# STAFF REPORT

## WASHOUGAL RIVER OAKS COTTAGE DEVELOPMENT

### (File No. Subdivision SUB20-01)

Staff Report Date: December 8, 2021

**GRADING AND  
DRAINAGE PLAN**

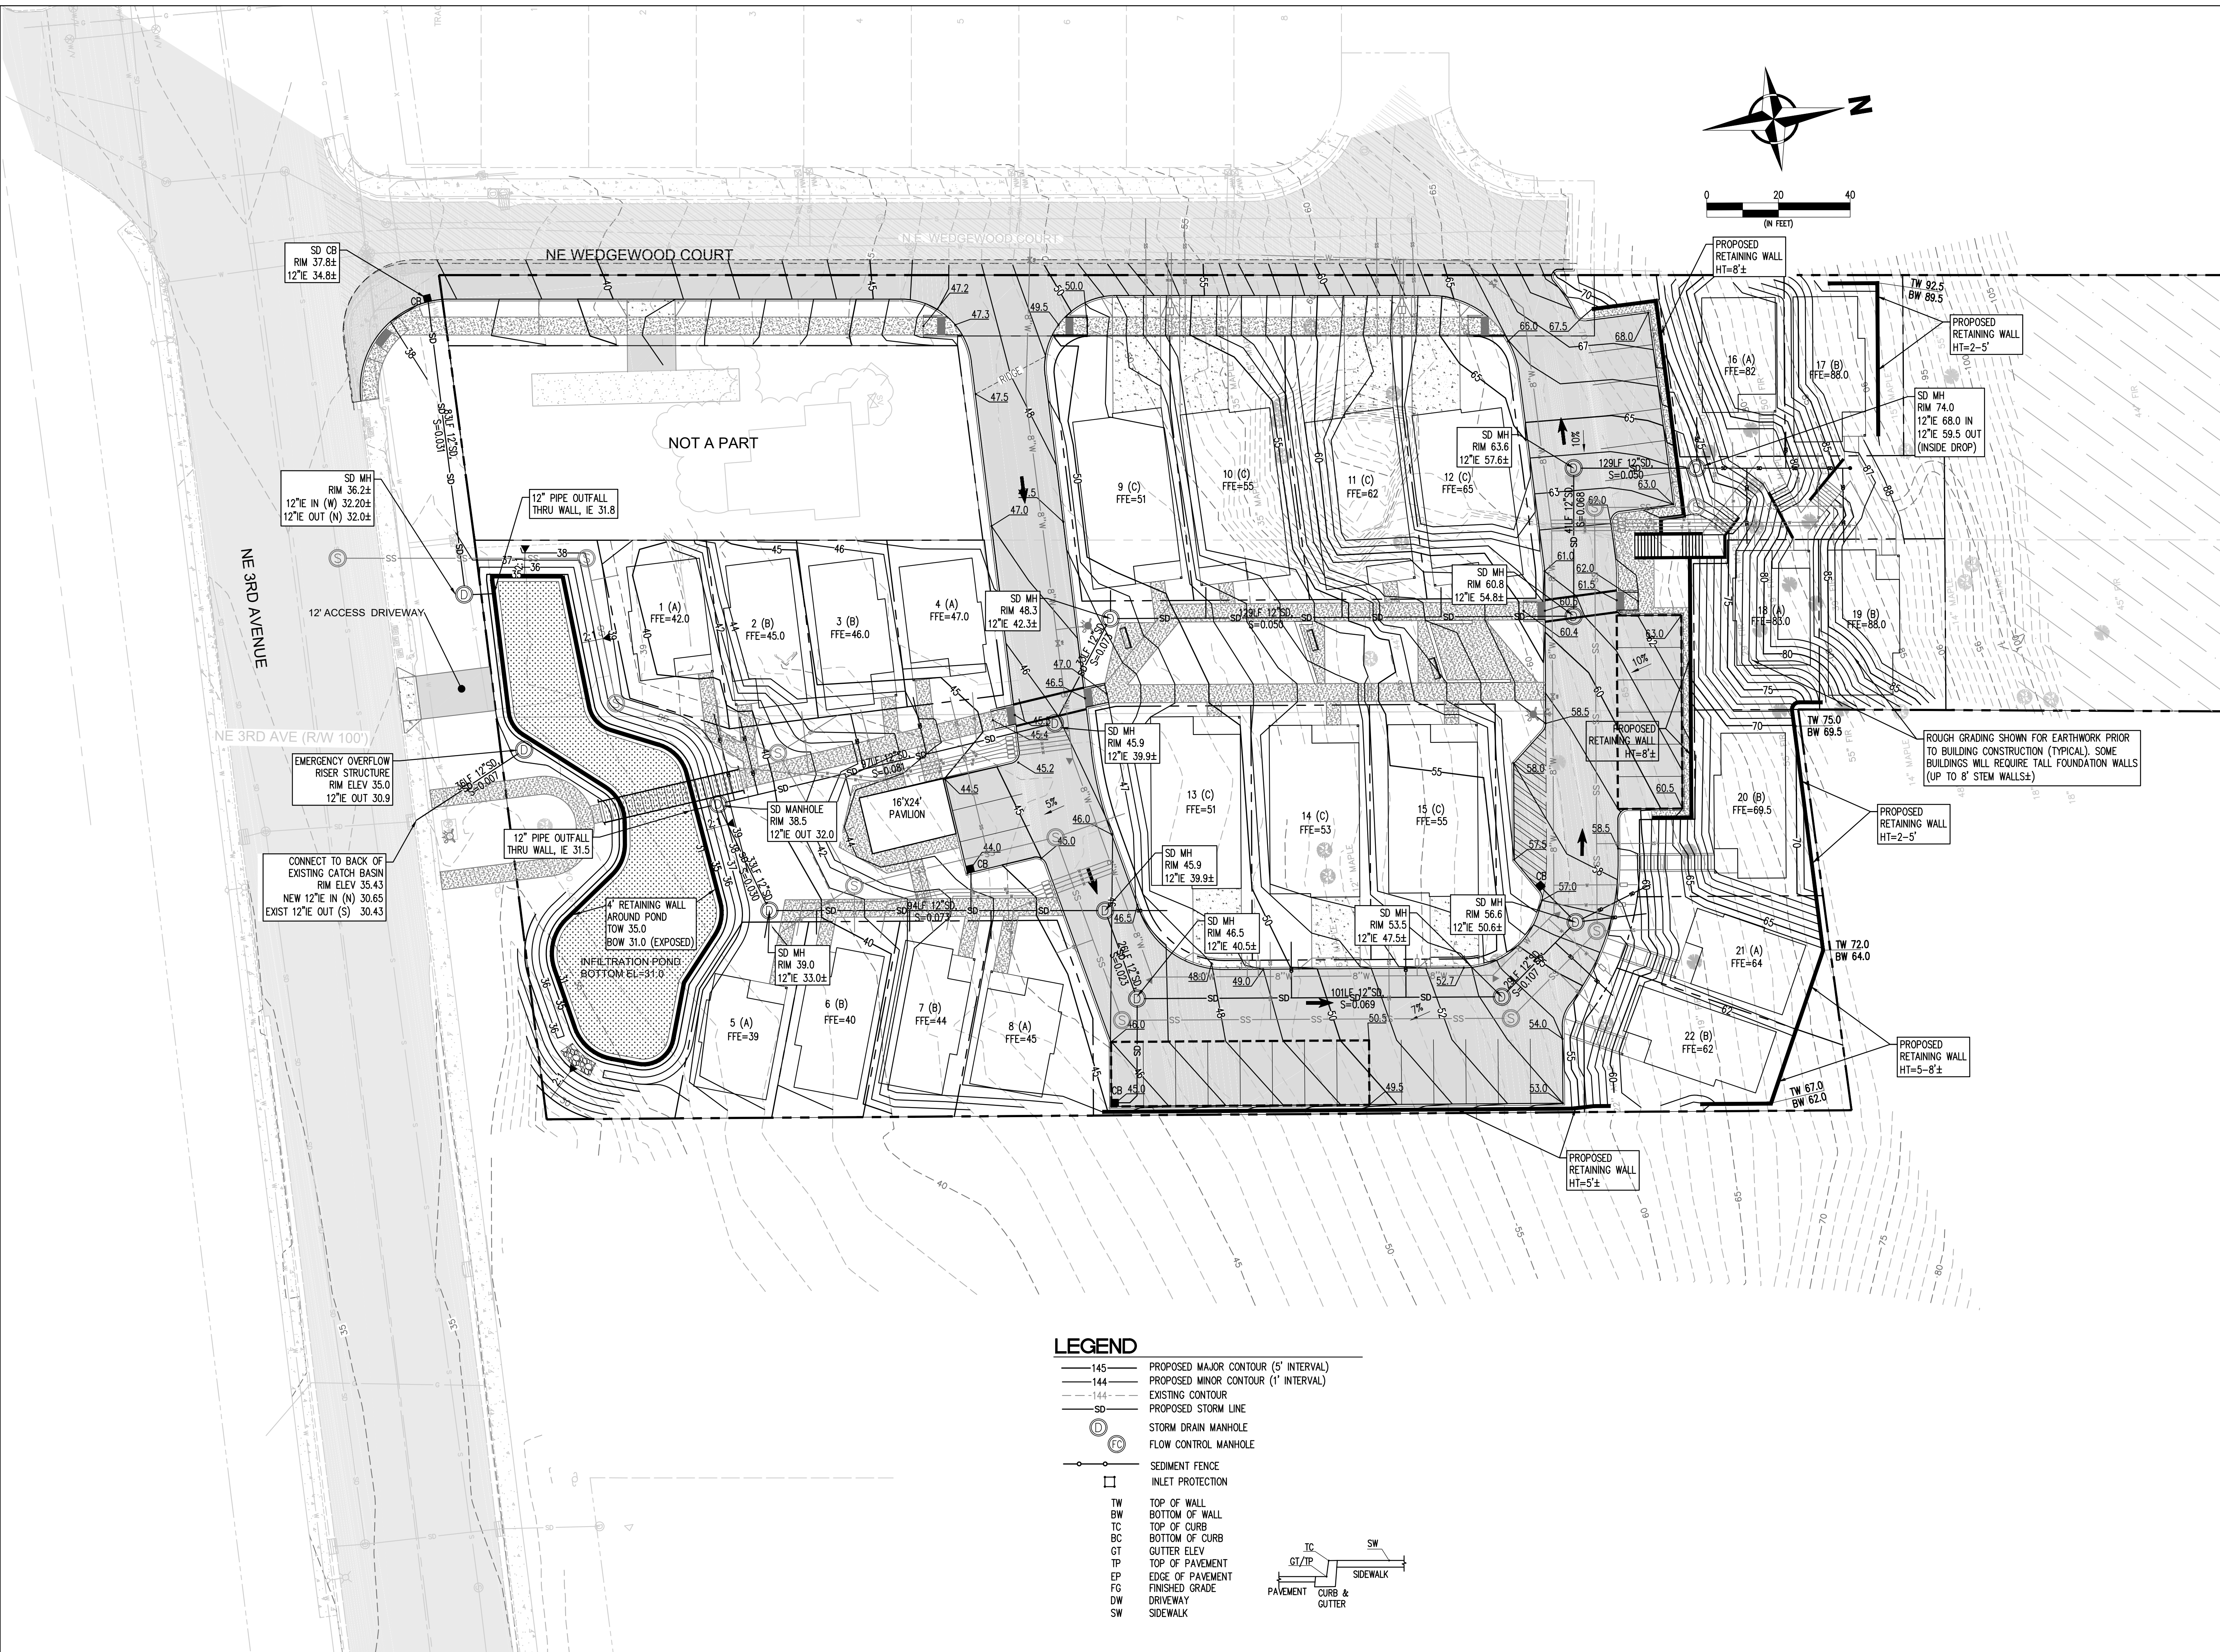
The preliminary grading and drainage plan provides a stormwater system consisting of catch basins, field inlets, a 12-inch storm line conveyance system, manholes, flow control manhole, emergency overflow system, and a stormwater treatment facility.

County SWMM has not been adopted by the City of Camas. Therefore, staff recommends a condition of approval that prior to final engineering plan approval, the applicant should submit a revised geotechnical report with infiltration testing conducted in accordance with Ecology's current 2019 SWMMWW and resubmit for review with the revised stormwater drainage report.

## SITE UTILITY PLAN

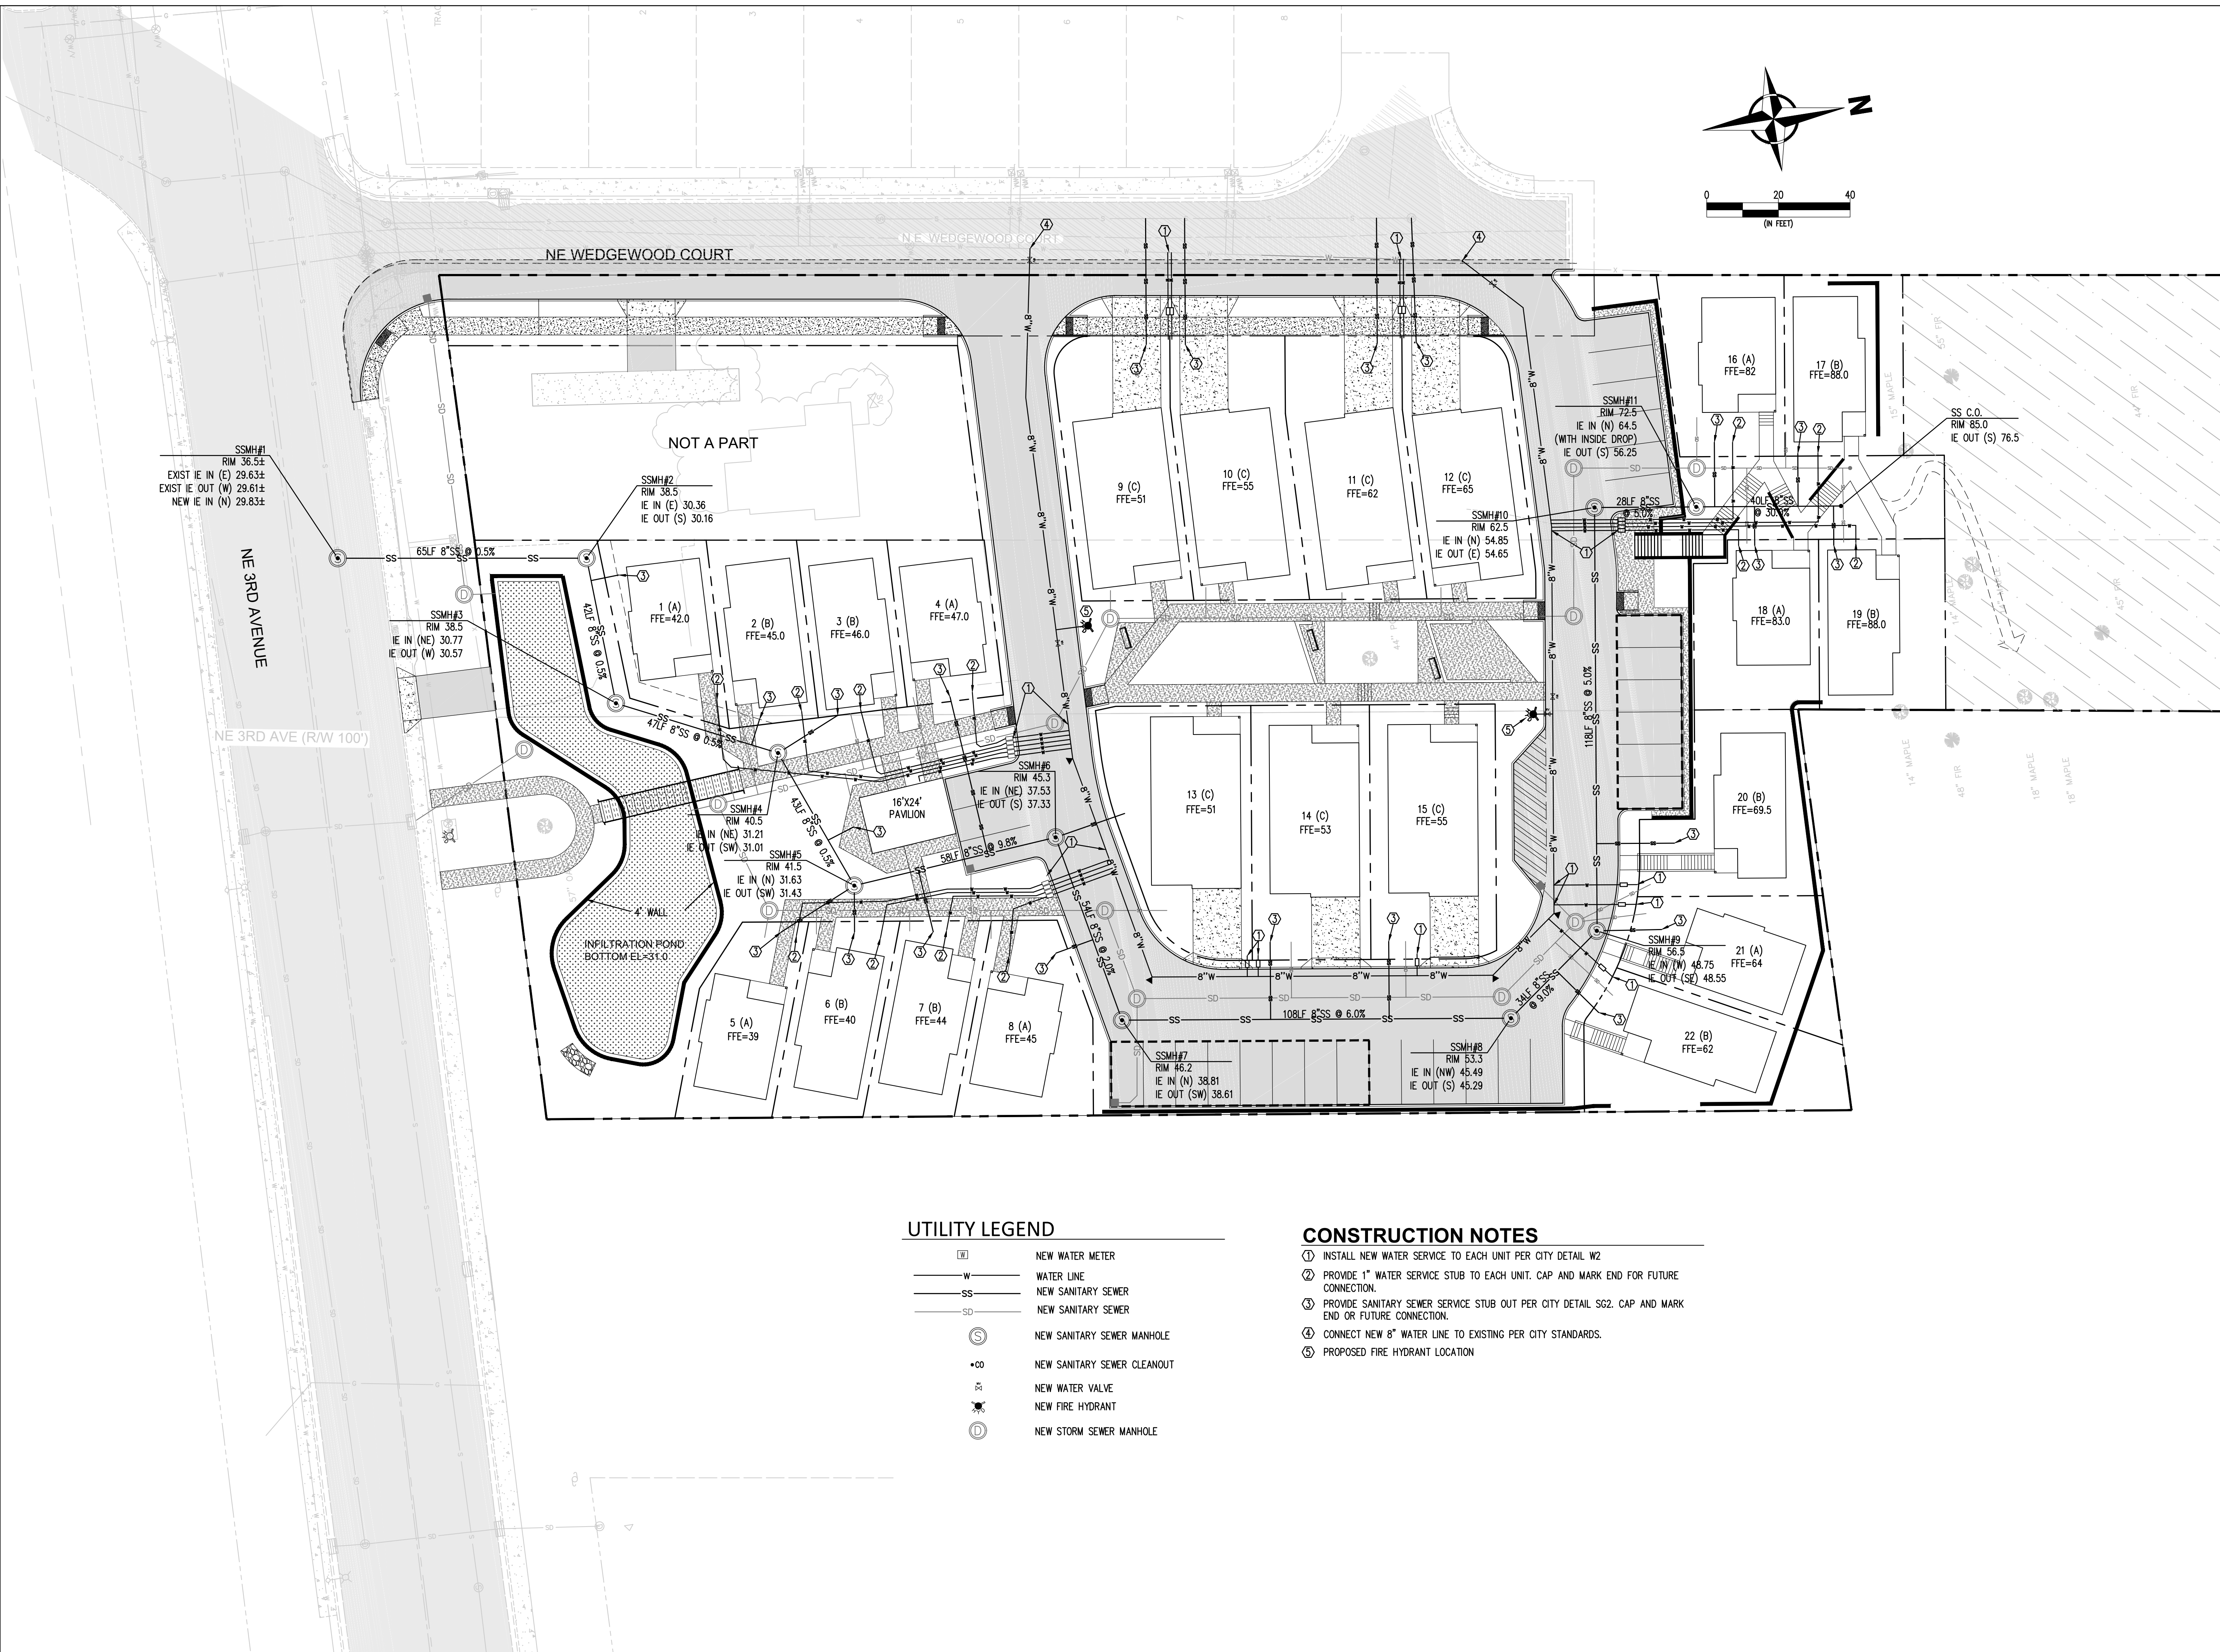
The preliminary utility plan shows three (3) locations that propose a cluster of four or more 1-inch water services, located side-by-side, and tapped off the 8-inch water main (Lots #1- #4 & the pavilion, Lots #5 - #8, and Lots #16 - #19). Staff recommends a condition of approval that prior to final engineering plan approval, the applicant should submit a revised utility plan that shows one 6-inch tap at each of the three locations where there are a cluster of four or more 1-inch taps located side-by-side. The 6-inch tap is to extend beyond the curb, with a 6-inch manifold provided for the cluster of 1-inch services to said Lots #1- #8, the pavilion, and Lots #16 - #19.

Staff recommends a condition of approval that prior to final plat approval, the applicant is to provide to the city a 20-foot wide utility access and maintenance easement over and under the water main located in the proposed private street, Tract \_\_\_.

CLIENT:	DD&C, LLC	DRAWN:	JR
PROJECT:	2531 NE 3rd Subdivision 2531 NE 3rd Avenue Camas, WA 98607	DATE:	7/30/2018
		FIGURE:	2
		PRO. #:	G0941800

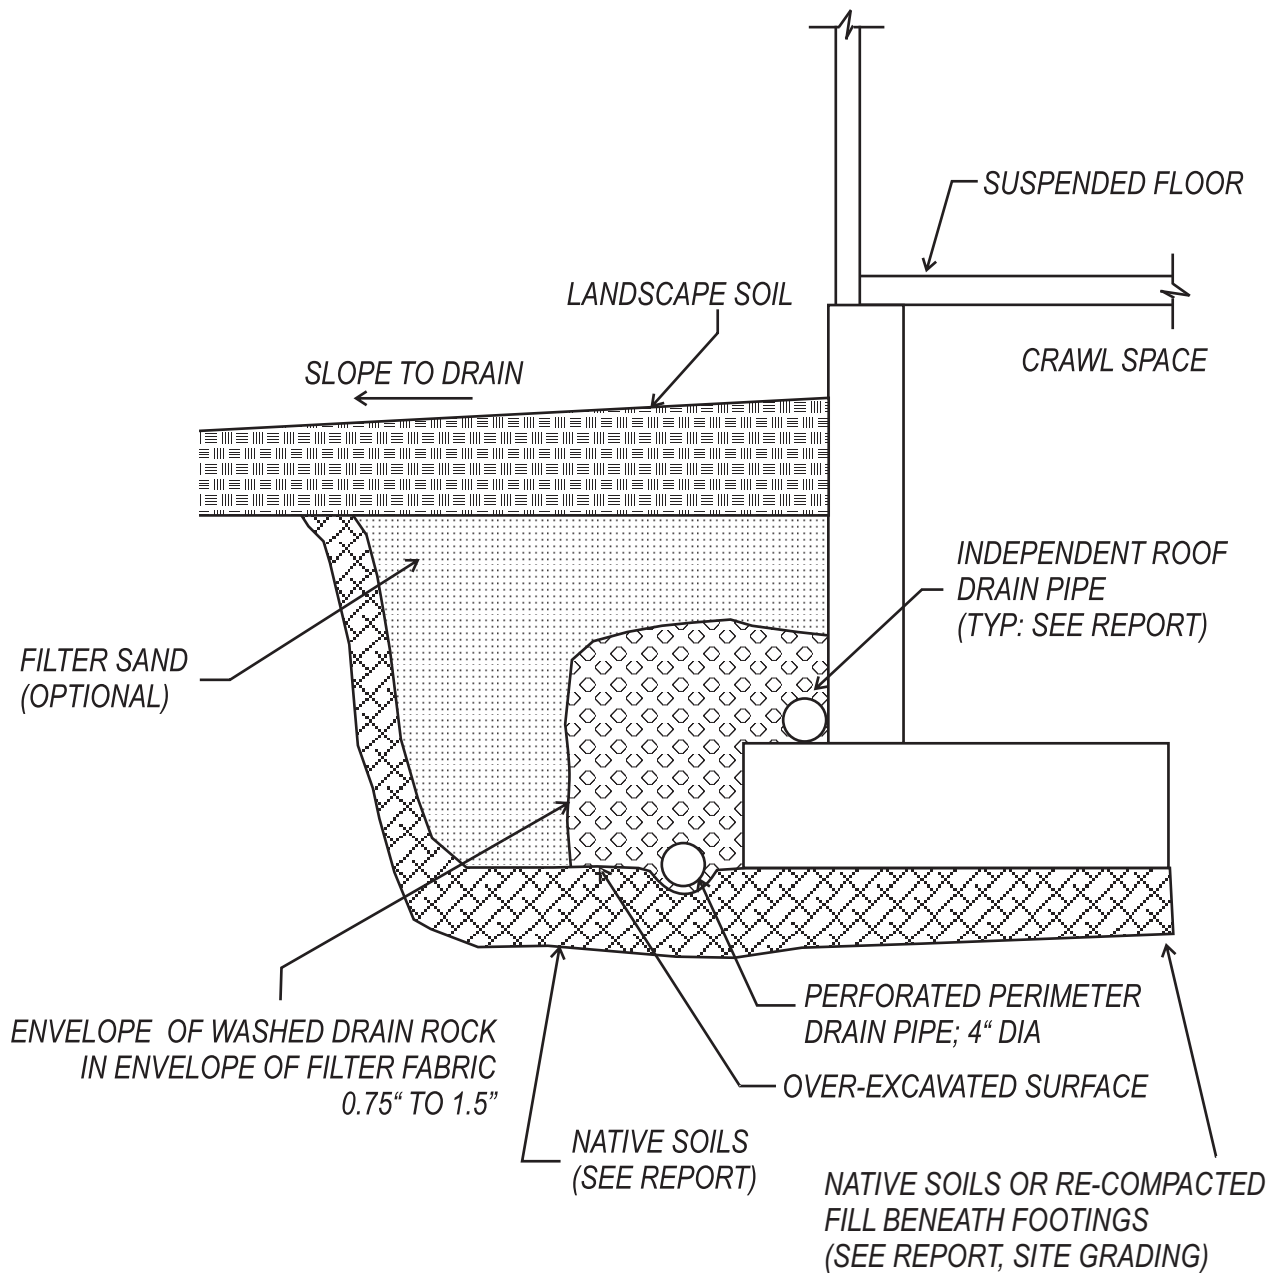
5. The "Slope and Landslide Hazards" section indicates that there are slopes greater than 15%, but they do not define what the maximum slopes on the property are. We recommend SWT more thoroughly describe the slope conditions on the project site and explain why the slopes are not considered a hazard that could impact the proposed project. While not required, consideration should be given by SWT to performing supplemental subsurface explorations in the area noted as "Geologically Hazardous" (due to steep slopes), as shown on Sheet P-1.0.
